Subregional RTEP Committee – Mid-Atlantic FirstEnergy Supplemental Projects Penelec Transmission Zone

s3290: Originally presented in 7/20/2023 and 2/15/2024 SRRTEP Mid-Atlantic meetings. Changes are marked in red.

Penelec Transmission Zone Scope Change Niles Valley 115 kV Ring Bus

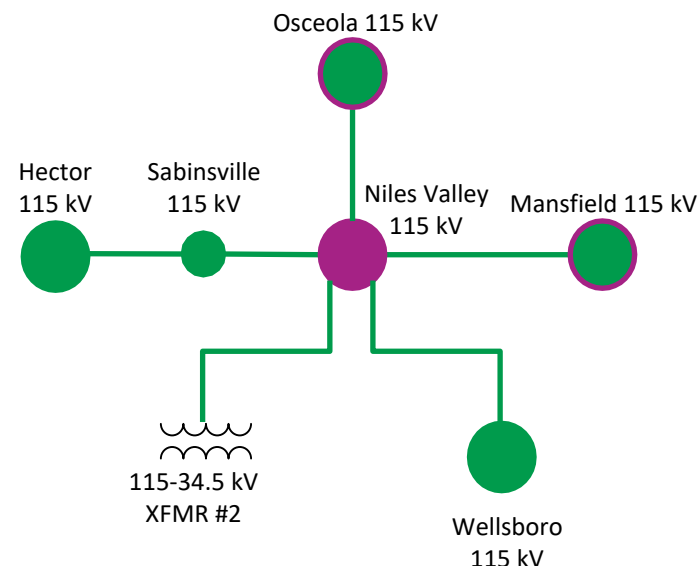
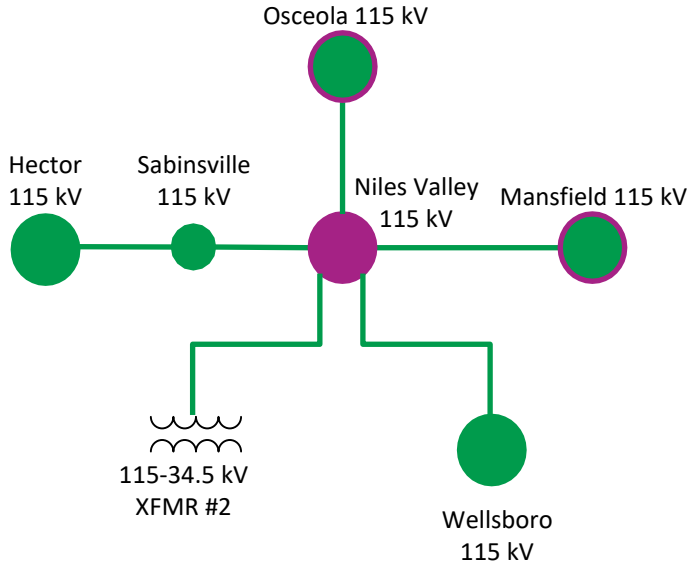
s3290: Originally presented in 7/20/2023 and 2/15/2024 SRRTEP Mid-Atlantic meetings. Changes are marked in red.

- Construct a six breaker ring bus
- Remove Niles Valley 115-34.5 kV Transformer #1
- Remove the 115 kV bypass switch between Wellsboro and Mansfield line exits (s2835)
- **Replace existing 12.6 MVAR capacitor bank with new 14.4 MVAR capacitor bank**
- Upgrade terminal equipment to transmission line ratings and adjust relay settings

Estimated Project Cost: \$16.0M
Projected In-Service: ~~11/04/2028~~ 4/28/2028
Project Status: Engineering
Model: 2023 Series 2028 RTEP Case
